# SERVICE INSTRUCTION

Service Instruction No. 1554  
Engineering Aspects are  
FAA Approved

SUBJECT: Zip Strap Replacement

MODELS AFFECTED: TIO-540-J2B, -J2BD; LTIO-540-J2B, -J2BD

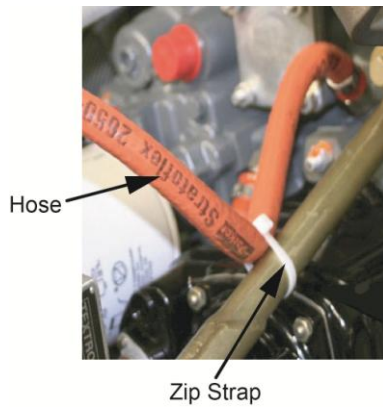
Evidence in the field has shown instances of chafing (Figure 1) on the turbocharger support rod (of affected Lycoming engine models). Figure 2 shows the proximity of the identification tag on an oil hose to one of the turbocharger support rods. Rub marks also were found in the turbocharger support rod where the paint/plating was worn away.

- Friction from the identification tag (Figure 3) on the oil supply hose for the bypass valve and on the turbocharger oil inlet hose
- Zip straps which attach the oil hoses to the turbocharger support rod positioning the identification tags on each of the oil hoses too closely to the turbocharger support rod

This Service Instruction is notification of corrective action to improve protection against chafing of the turbocharger support rod. The zip straps are to be replaced with four clamps and hardware identified in Table 1 as per corrective action instructions herein. **The zip straps are no longer to be used.**

Zip Strap  
Figure 4

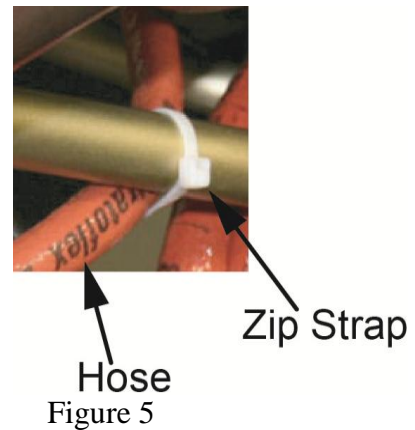
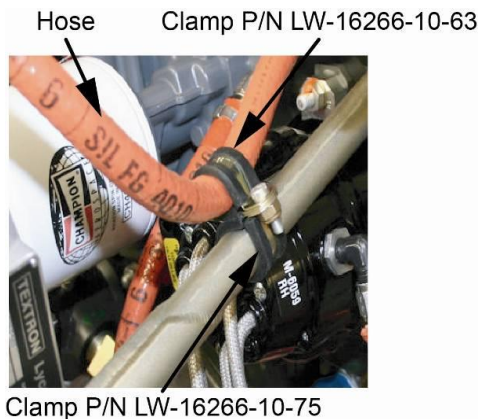
1. Remove and discard the zip strap from the oil supply hose for the bypass valve (Figure 4) and the oil inlet hose for the turbocharger (Figure 5).
2. Examine the turbocharger support rod for chafing or wear from any of the metal identification tags. If chafing or wear is found on any of the support rods, replace the entire turbocharger mount assembly.

Zip Strap Attached to the Oil Supply Hose for the Bypass Valve and Lower Turbocharger Support Rod

3. Examine the oil supply hose for the bypass valve (Figure 4) for chafing. Examine the turbocharger oil inlet hose (Figure 5) for chafing. Replace any worn or chafed oil hose.
4. Install the two new clamps (P/N LW-16266-10-63 and P/N LW-16266-10-75) with fasteners on the oil supply hose for the bypass valve in the specified location shown in Figure 6.
5. Install the two new clamps (P/N LW-16266-10-75) with fasteners on the oil inlet hose for the turbocharger as shown in Figure 7.
6. Make sure the oil hoses can move freely, are not bent, kinked, or stressed, and not touching any part of the engine or engine accessory.
7. Record zip strap removal, clamp installation, (and any oil hose or turbocharger support rod replacement) in accordance with this Service Instruction in the engine logbook.

Installed Clamps on Oil Supply Hose for the Bypass Valve and Lower Turbocharger Support Rod

Figure 6

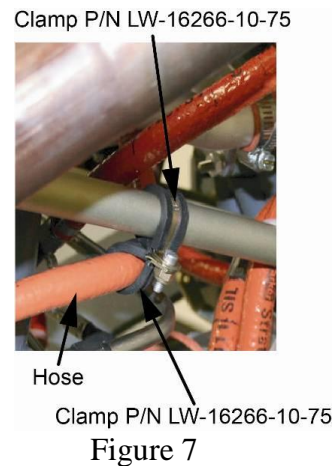
Zip Strap Attached to Turbocharger Oil Inlet Hose and Upper Turbocharger Support Rod

Installed Clamps on Turbocharger Oil Inlet Hose and Upper Turbocharger Support Rod
